May 9, 2017

FRESNO CHAFFEE ZOO WARTHOG EXHIBIT**ADDENDUM NO. 1**

FRESNO CHAFFEE ZOO WARTHOG EXHIBIT**ADDENDUM NO. 1 CONTINUED**

E2

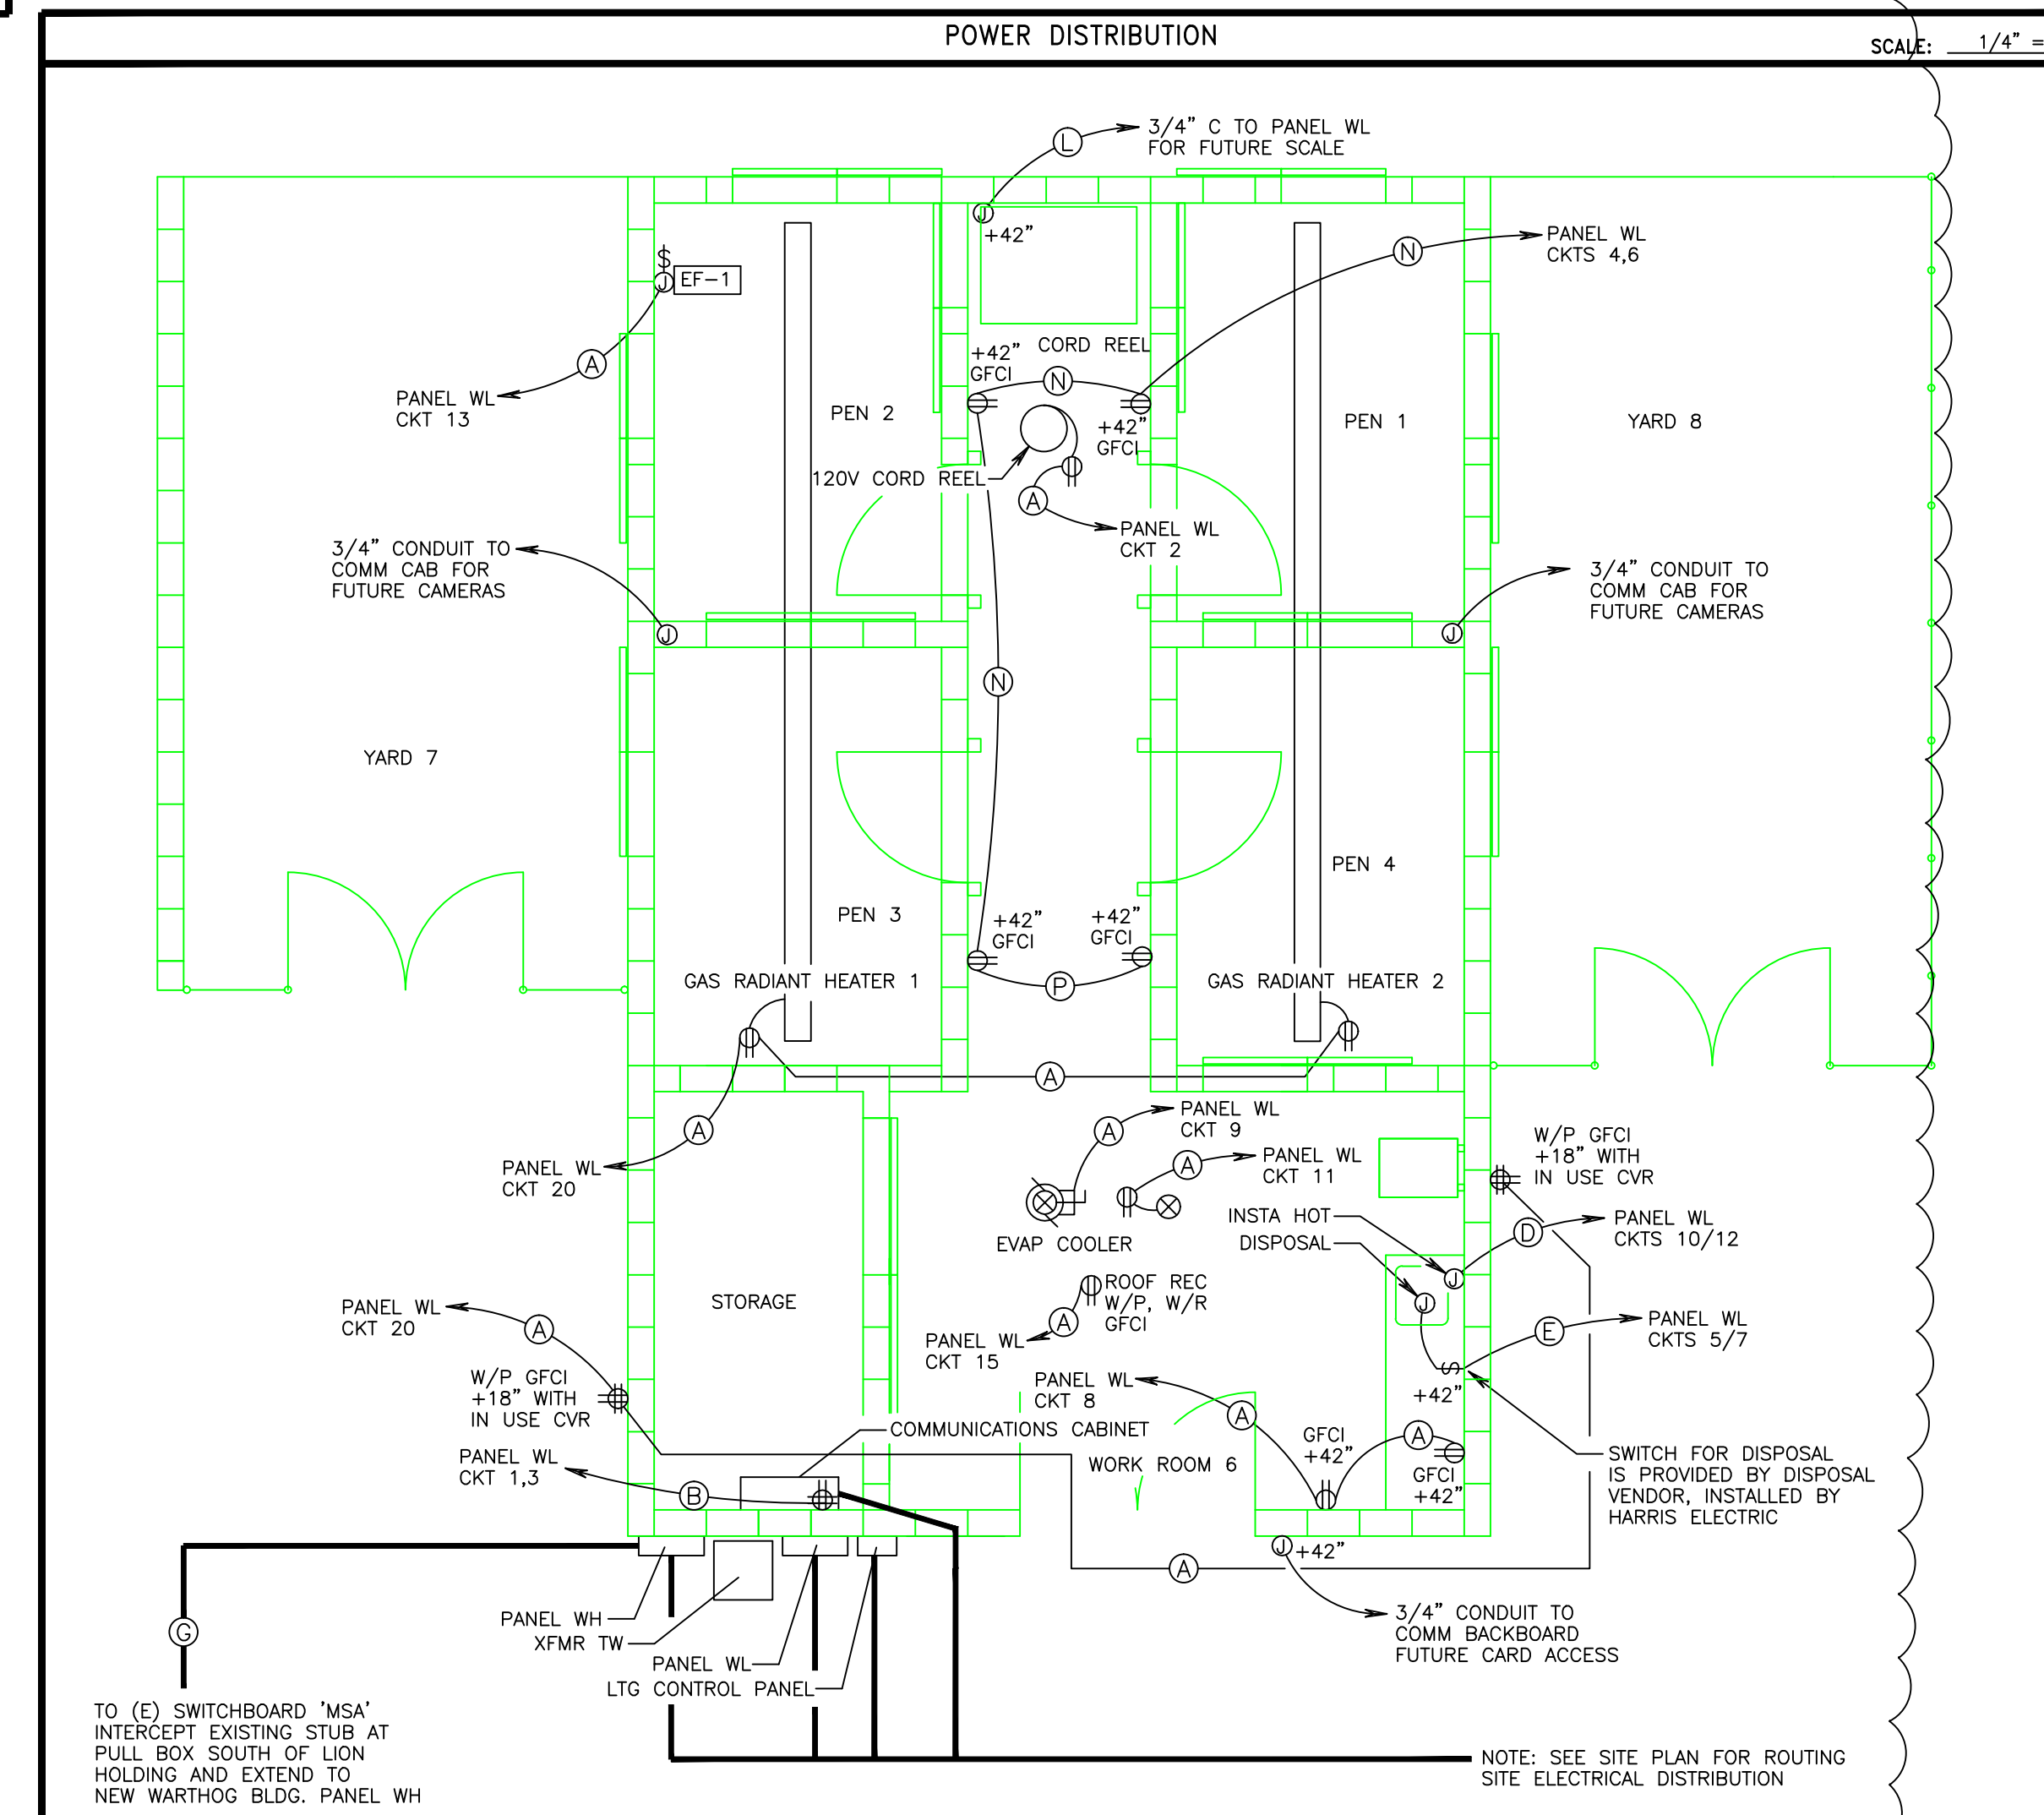
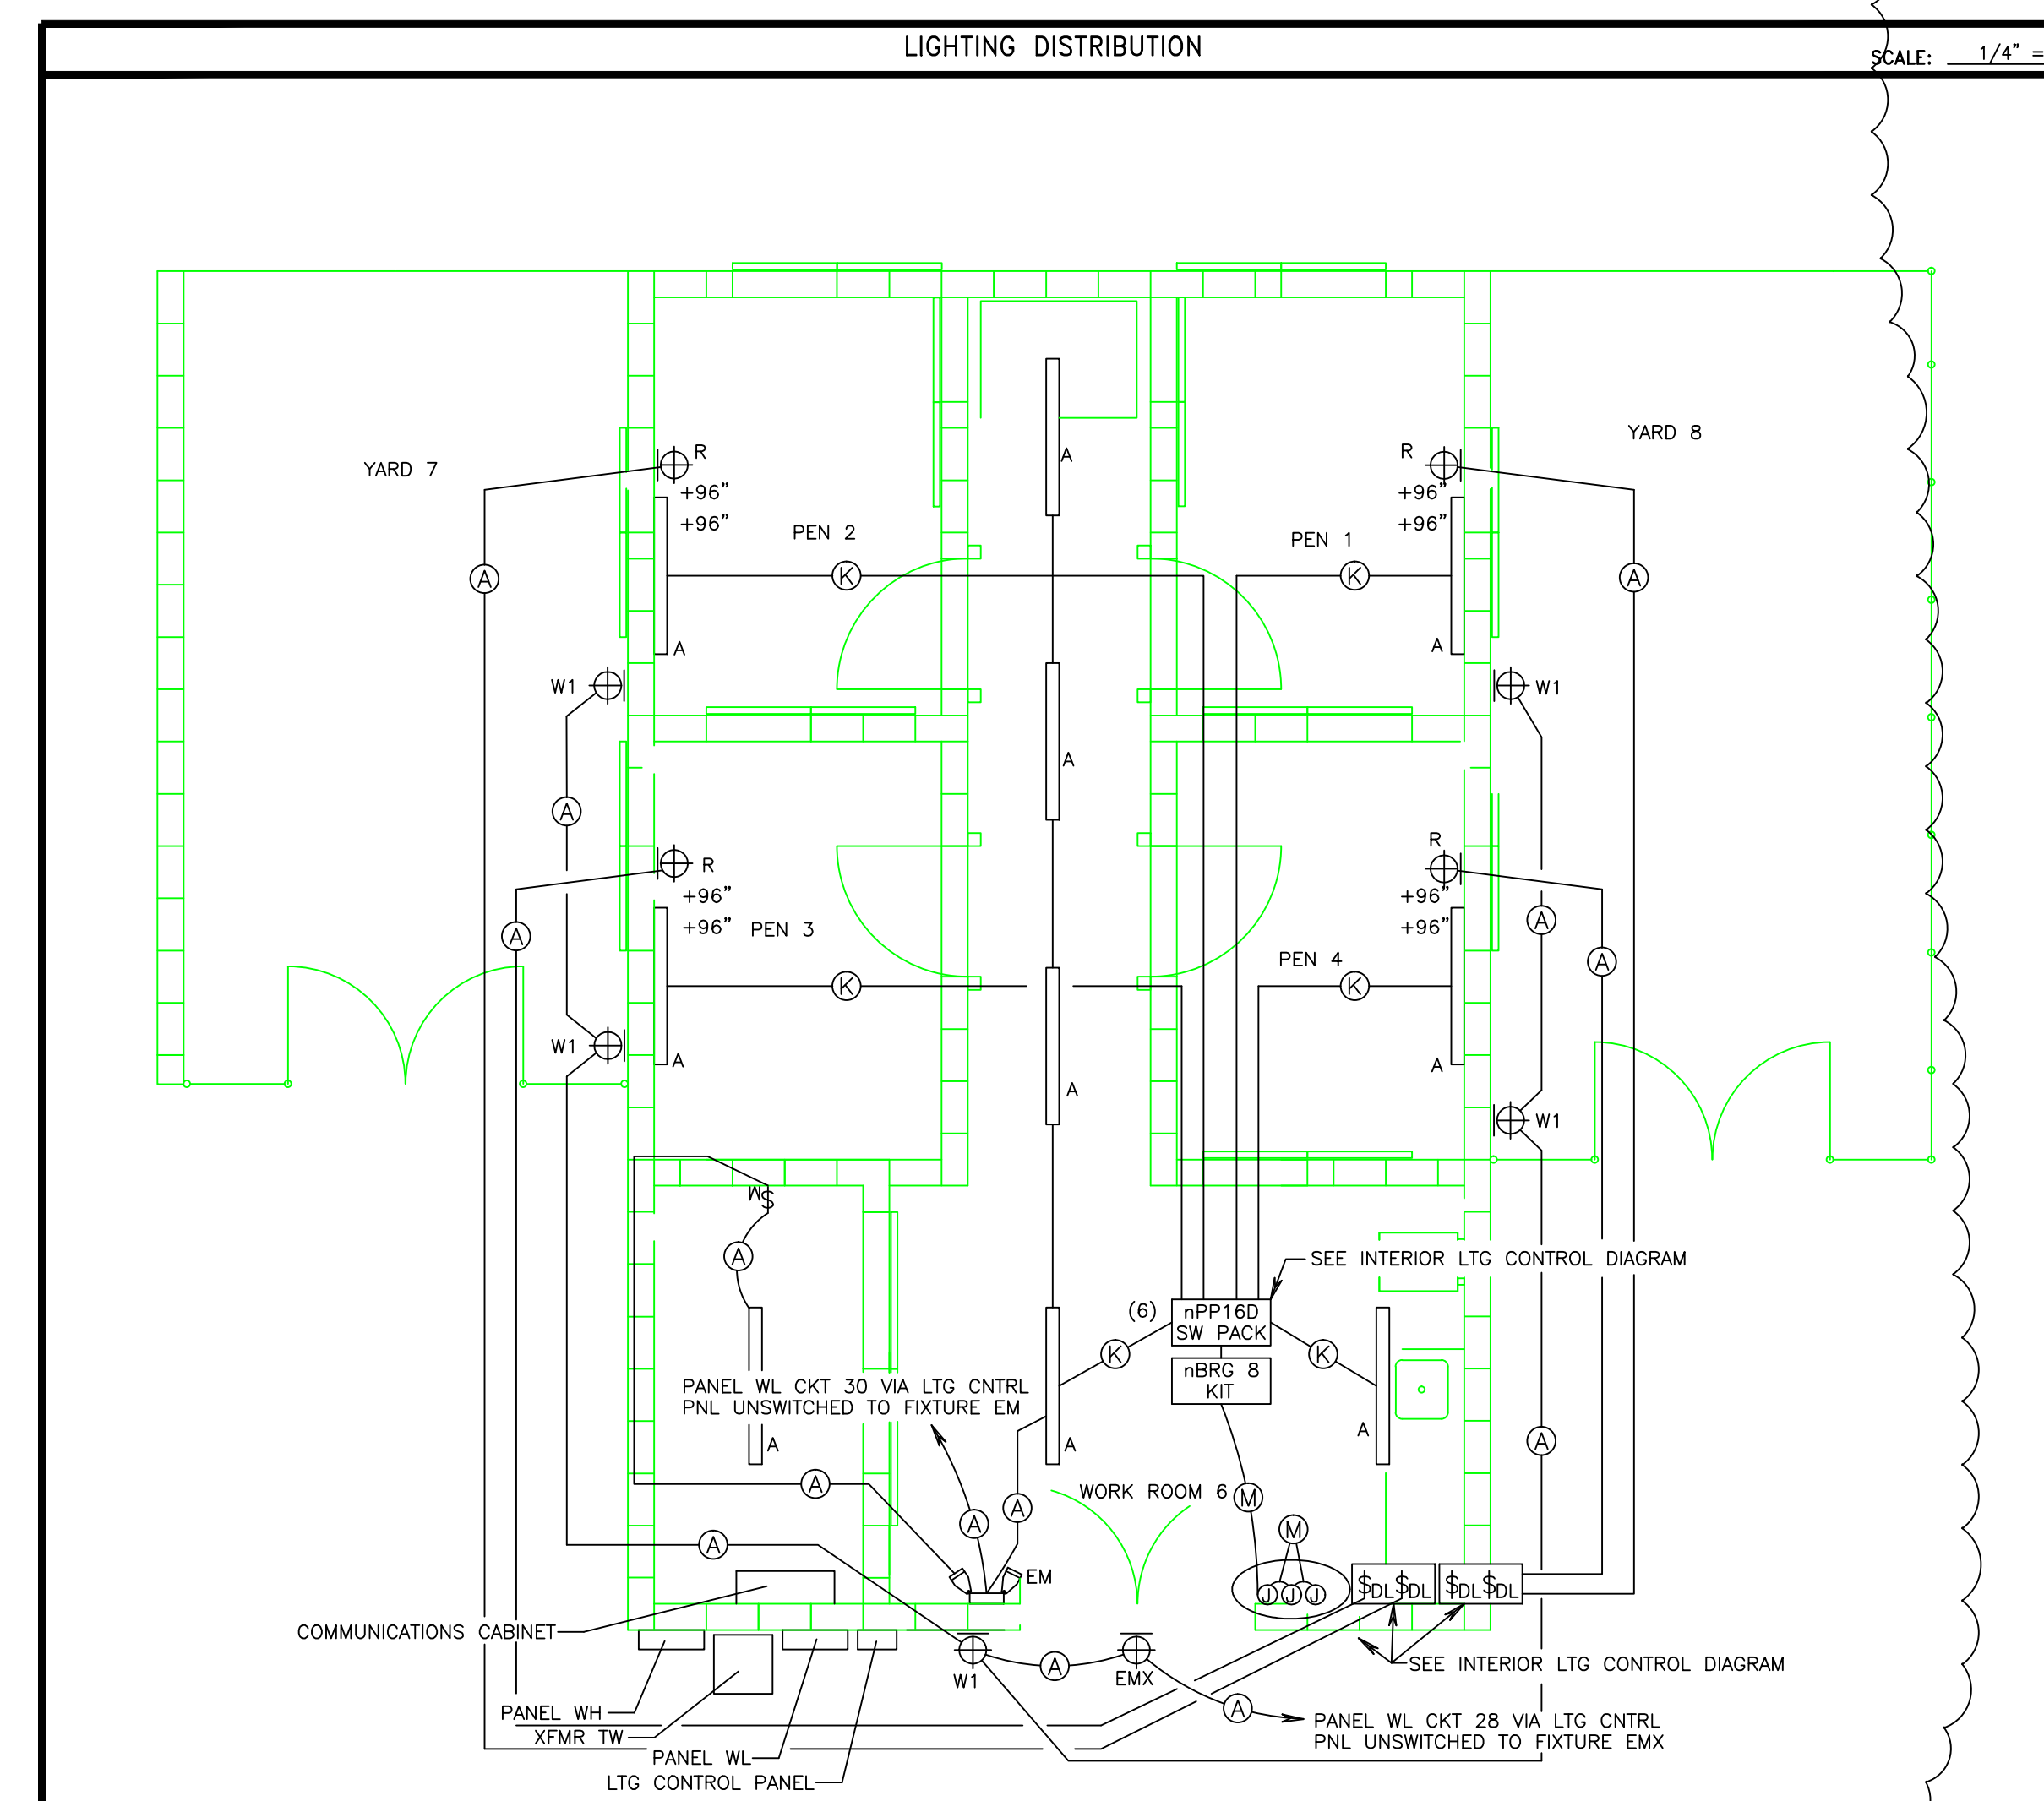
5. **REPLACE SHEET E2 WITH ATTACHED REVISED SHEET E2. PANEL SCHEDULE HAS BEEN REVISED TO INCLUDE BOOSTER PUMP.**
6. **REPLACE SHEET L14.1 WITH ATTACHED REVISED SHEET L14.1 . IRRIGATION SCHEDULE HAS BEEN REVISED TO SHOW BOOSTER PUMP.**

CKT NO.	BREAKER	OUTLET	WATTS	277-480 V			REMARKS
				100 AMP	100A MAIN	4-WIRE SURFACE N3R	
1	20 3	X					BOOSTER PUMP
2	20 1						SPARE
3	-						SPARE
4	20 1						SPARE
5	-						SPARE
6	20 1						SPARE
7	-						SPARE
8	-						SPARE
9	-						SPARE
10	-						SPARE
11	-						SPARE
12	-						SPARE
13	-						SPARE
14	-						SPARE
15	-						SPARE
16	-						SPARE
17	-						SPARE
18	-						SPARE
19	60 3	X	6900				45KVA XFMR TW / PNL WL
20	-						SPACE
21	-		6797				SPACE
22	-						SPACE
23	-		8841				SPACE
24	-						SPACE
